S.4.55 MODIFICATION REPORT

S.4.55 MODIFICATIONS TO DA 9130

REPLACEMENT OF THE MERRITTS DOUBLE CHAIRLIFT WITH A GONDOLA LIFT & ASSOCIATED WORKS THREDBO ALPINE RESORT KOSCIUSZKO NATIONAL PARK

AUGUST 2019

Figure 1: Additional vegetation removal as a result of the proposed modification.

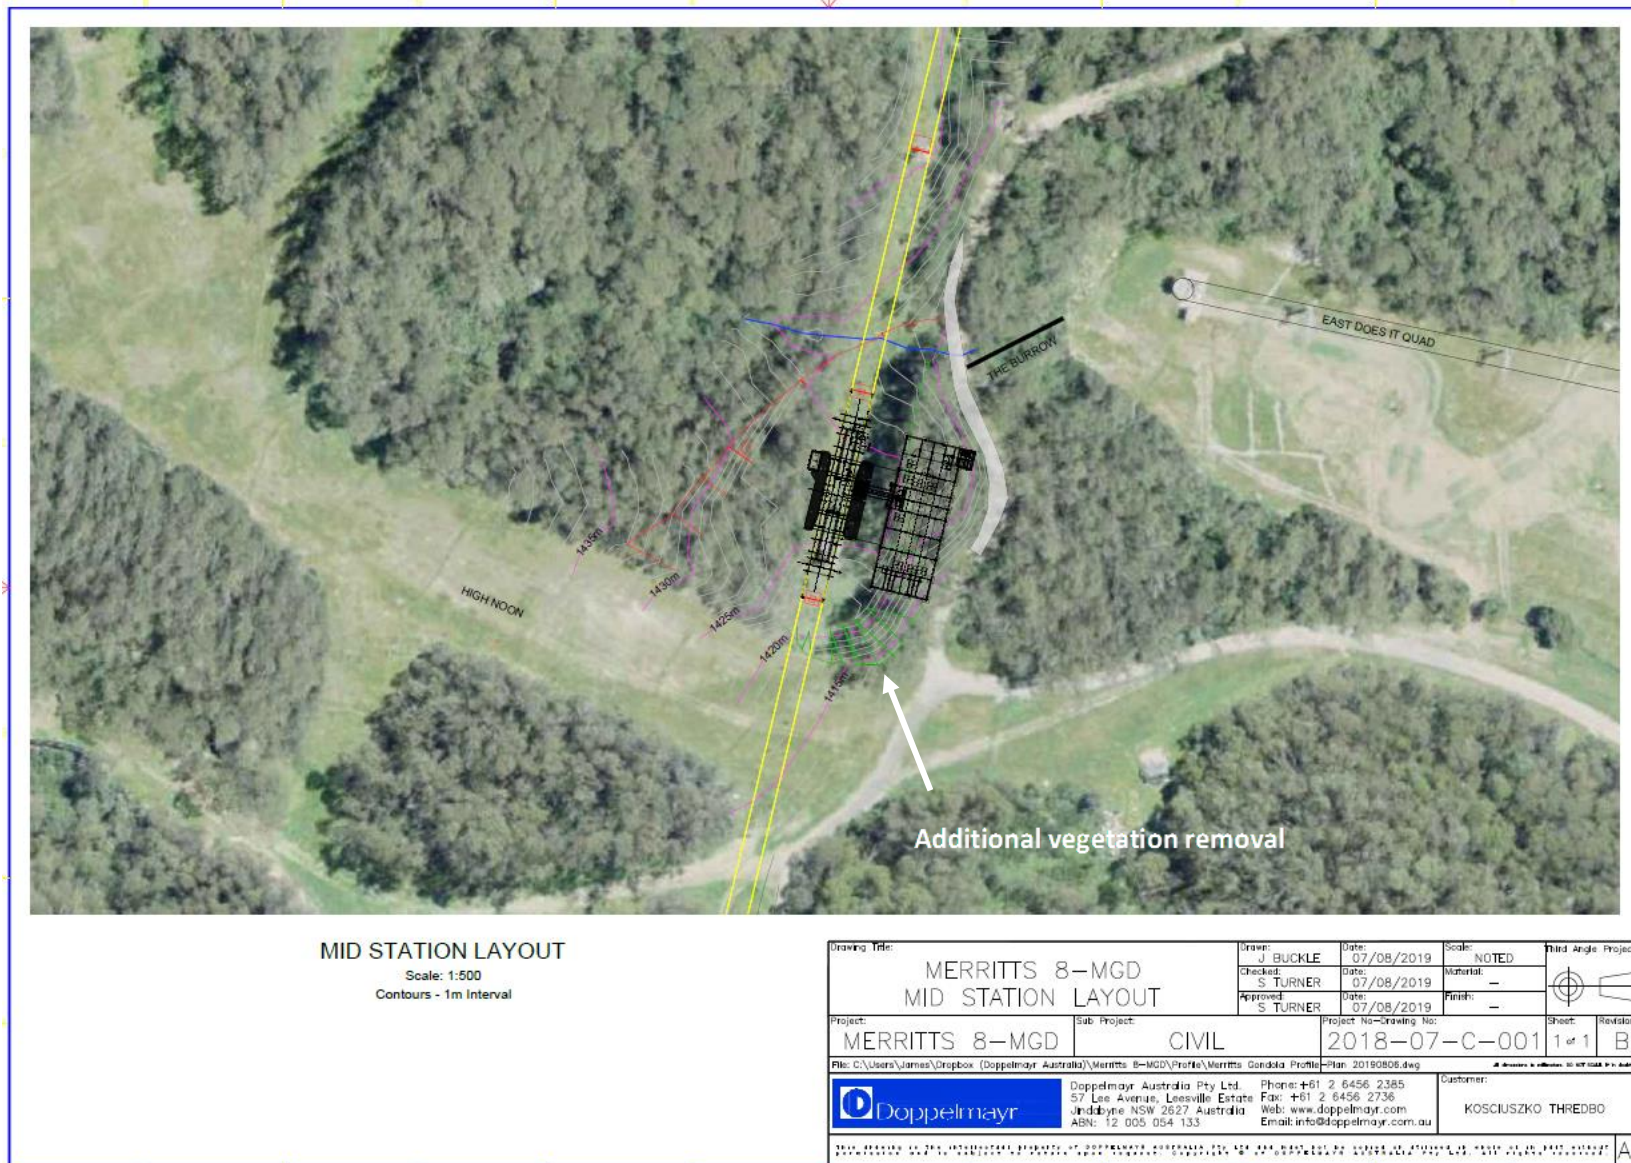
As requested, I have reviewed the potential additional impacts associated with the revised mid station design of the approved Merritts Gondola lift. The additional vegetation removal is estimated to comprise an additional 500 m² of Subalpine Woodland, on the south-eastern side of the mid station location, as shown in Photo 1 and Figure 1.
